**Economic Commission for Europe****Inland Transport Committee****World Forum for Harmonization of Vehicle Regulations****Working Party on Passive Safety****Fifty-seventh session**

**Regulation No. 16 (Safety-belts)****Proposal for Supplement 6 to the 06 series of amendments to Regulation No. 16 (Safety-belts)****Submitted by the expert from the European Association of Automotive Suppliers \***

The text reproduced below was prepared by the expert from the European Association of Automotive Suppliers (CLEPA) aimed at clarifying the provisions for dynamic testing of rear seat system, advanced restraint system approval and transitional provisions. It supersedes ECE/TRANS/WP.29/GRSP/2015/4. The modifications to the current text of UN Regulation No. 16 are marked in bold for new or strikethrough for deleted characters.

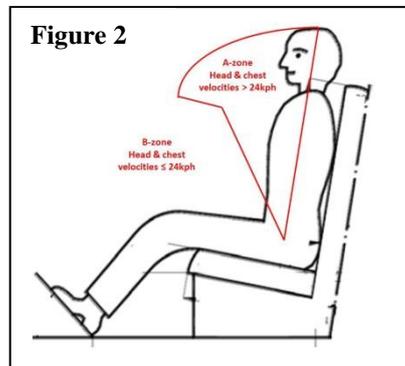
- "12.1. In case a restraint system has been granted/refused/extended/withdrawn 2/ approval for general use, those can be used for all vehicles compatible with the following dimensional conditions: no interior part in a quoted A-zone as shown below (figure 2): \*

Figure 1  
Rear seats restraint system setup for dynamic test

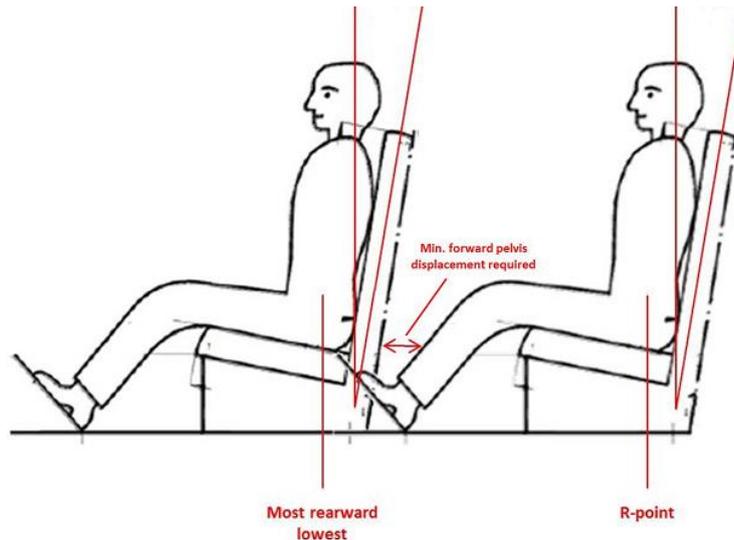
The seat in front of a tested seat shall be adjusted to the most rearward and lowest position appropriate for any contact with the manikin installed on the rear seat, then shifted forward for minimal pelvis displacement according to paragraph 6.4.1.3.2. and with a seat back angle at 10°, as derived from the 3-D H Point machine (Annex 19, Figure 1).

**This can be proven with a contour on CAD or drawing."**
